DESIGN/PROCESS CHANGE NOTIFICATION

1. Current TO220 single gauge design
2. Heat sink copper neck width of 6.00mm

Dimension about change from
unit:mm

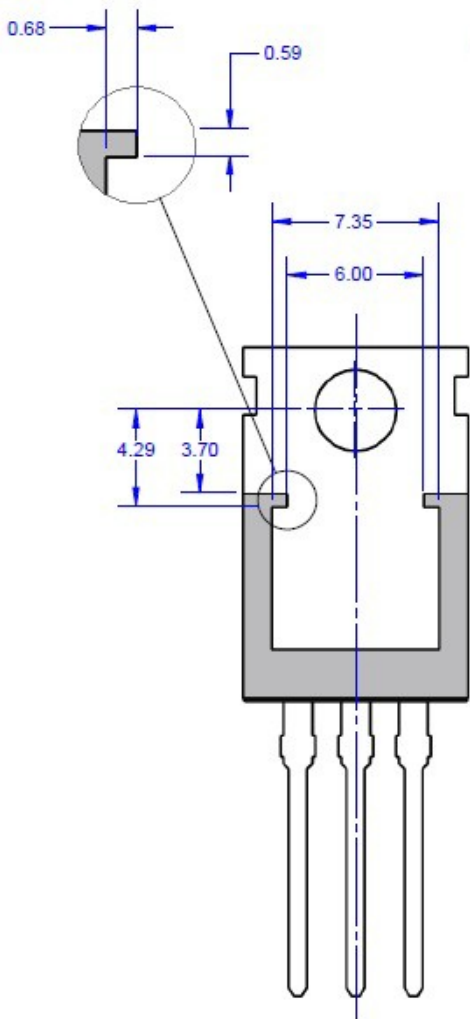
Description of Change (From) :

Dimension about change to
unit:mm

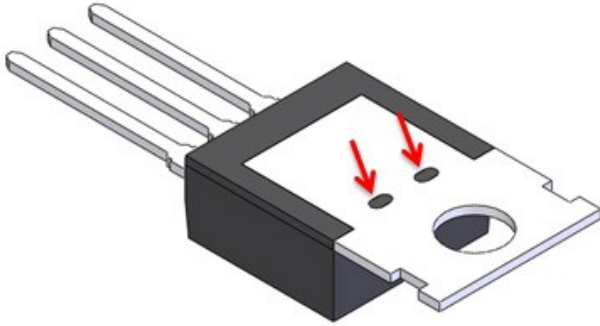
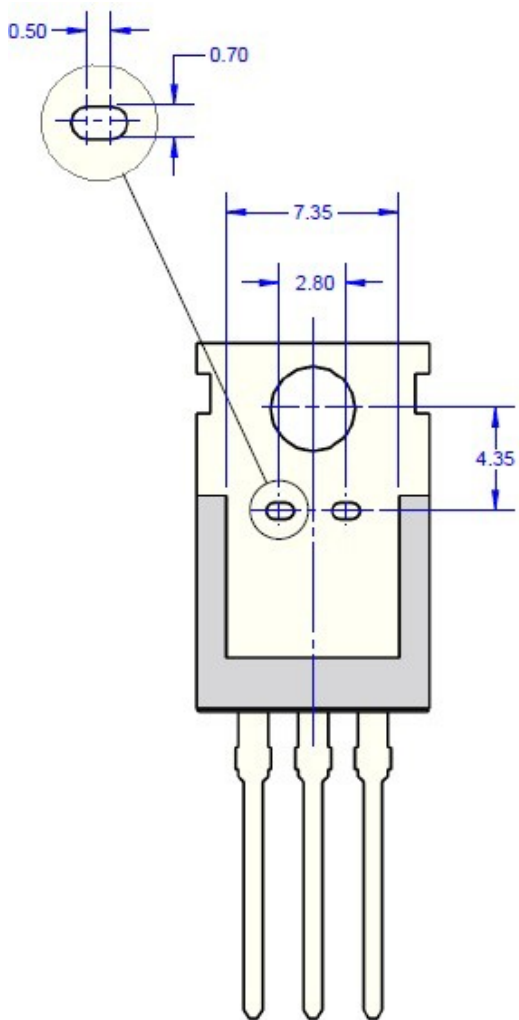
Description of Change (To) :

1. The addition of two oval holes on heat sink neck
2. Heat sink copper neck width enlarged to 7.36mm; total heat sink width not changed

To improve the durability of heat sink adhesion during customer mechanical application
